Attachment 1:

Further information requested under Section 92 of the Resource Management Act 1991

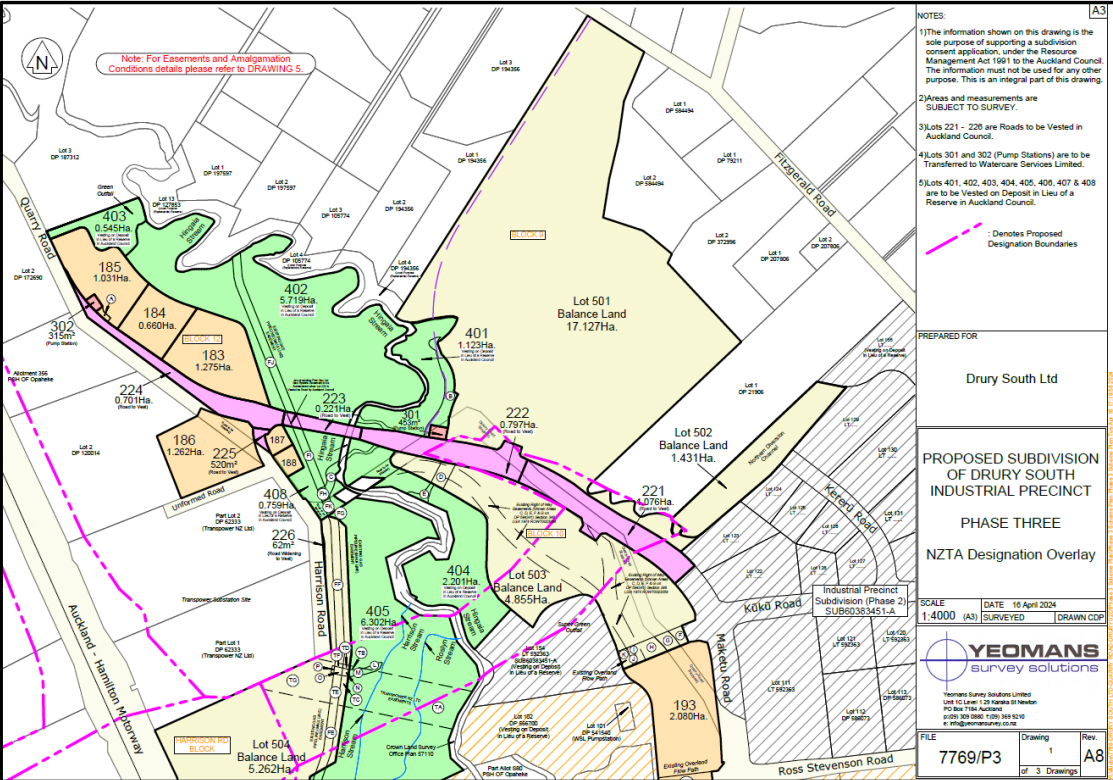
HW9	Table 7-2 Flood Impact Assessment Revision: C, 16/02/2024	<p>Table 7-2 indicates a flood displacement volume of 4010m³ and 0.16 ha increase in flood extents upstream of the proposed culvert crossing at CH20820 for the 1% AEP event with CC.</p>	To better understand the flood effects.	<p>A plan illustrating the flood extents outside of the NoR boundary are shown in Figure 10-4 of Flood Impact Assessment.</p> <p>The flood extent will be contained within the existing streams. This is because the stream channels have sufficient capacity to contain the increased water volume without overflowing their banks. Since flood extents for the 1% AEP with climate change are contained within the existing streams, flood extents for minor events</p>

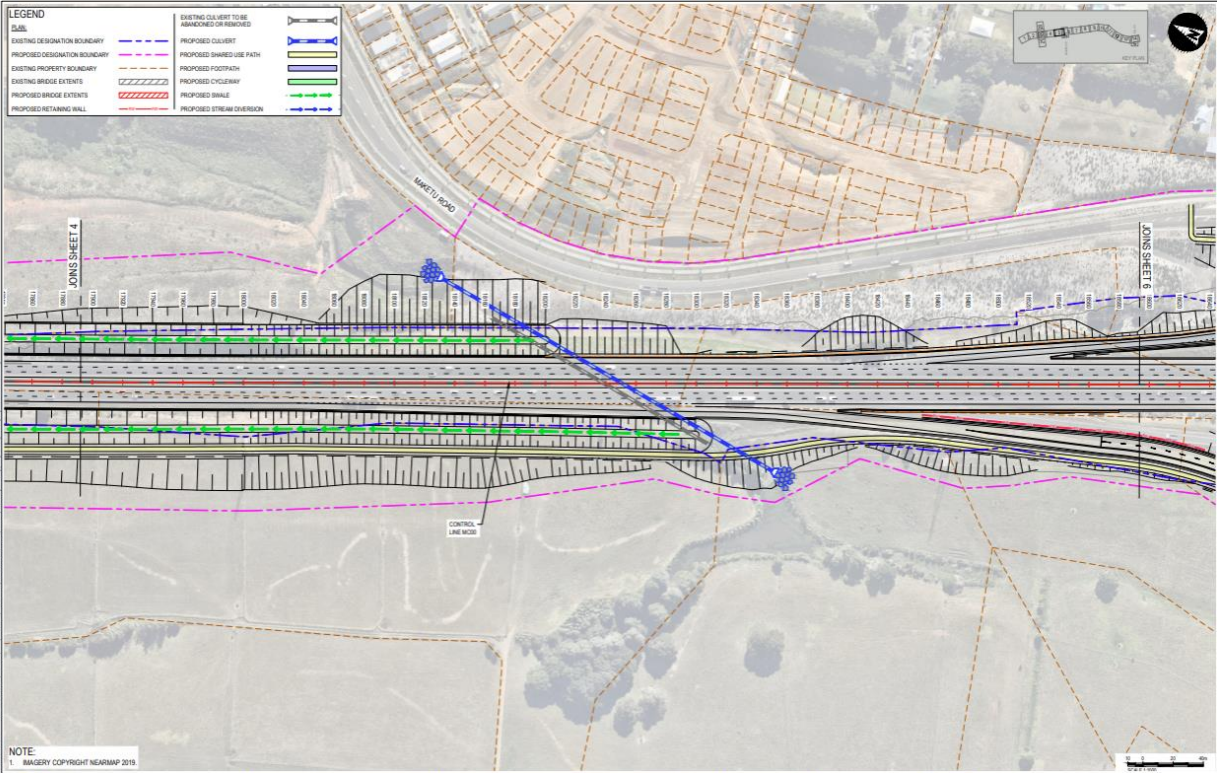
HW18	Drawing RR-0101-A	<ul style="list-style-type: none"> • Is the flow direction of the swale shown on drawing RR-0101-A correct? If so, where does the swale discharge to? <p>This query is relevant to a number of swales along the designation.</p>	To better understand the flood management.	Flows from this area will be discharged to Hingaia Stream via piped reticulation.

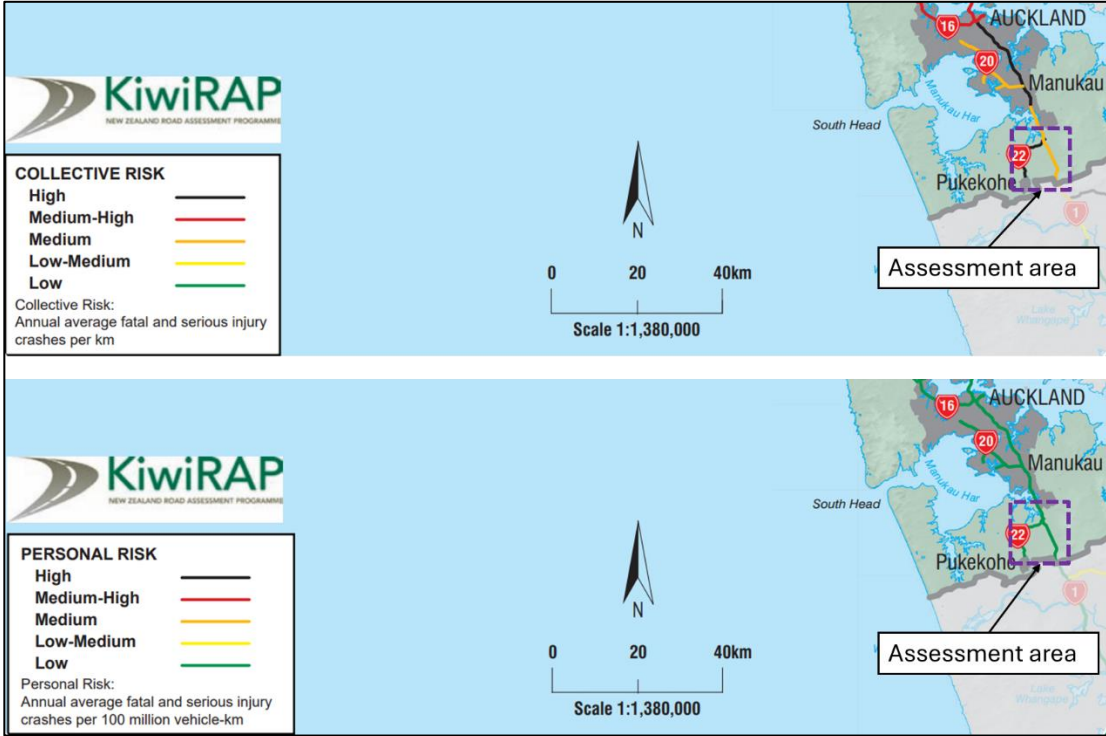
T5	NOR 5 Future Corridor – Intersection with Maketu Road	<ul style="list-style-type: none"> Please undertake traffic modelling of this intersection 	<p>The intersection traffic modelling presented in Appendix C does not cover the intersection with Maketu Road. Please can a modelling assessment of this intersection be provided, to determine whether its operation and queue</p>	<p>The intersection modelling documented in Appendix C (Assessment of Effects on Transport and Traffic) includes the Maketu Road intersection. This intersection is the 5-leg roundabout that forms the eastern side of the interchange. Refer figure below from Appendix C.</p>
